2023-T-117 - City of Niagara Falls GO/VIA Station – Interior Alterations and Upgrades

Date Issued: Wednesday, March 13th, 2024

Addendum No. 3

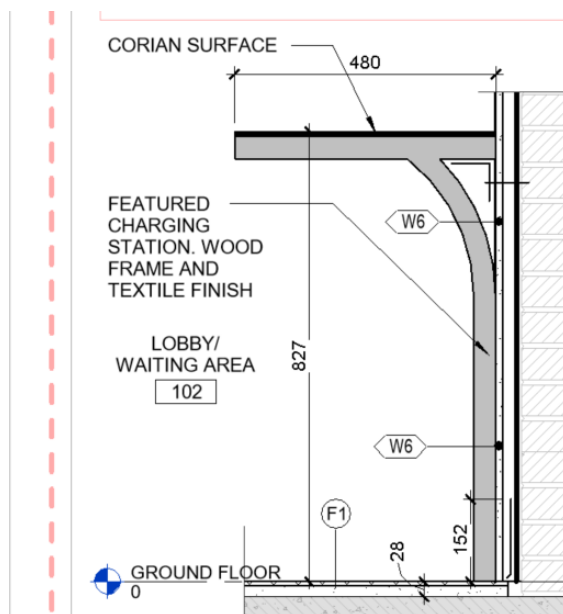
Do you have spec for ADO but they are not indicated on the door schedule.

ADOs are indicated in the Door Hardware section of specifications. Refer to sections 08 71 00 & 08 71 13.

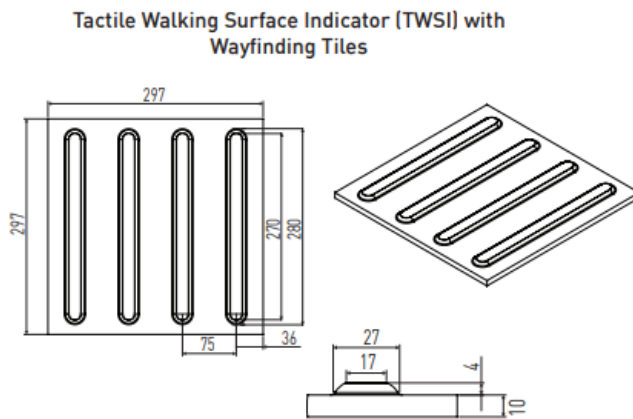
What is the spec for stair tread and risers with nosing?

Refer to Section 09 65 00 2.2 for stair tread and risers with nosing.
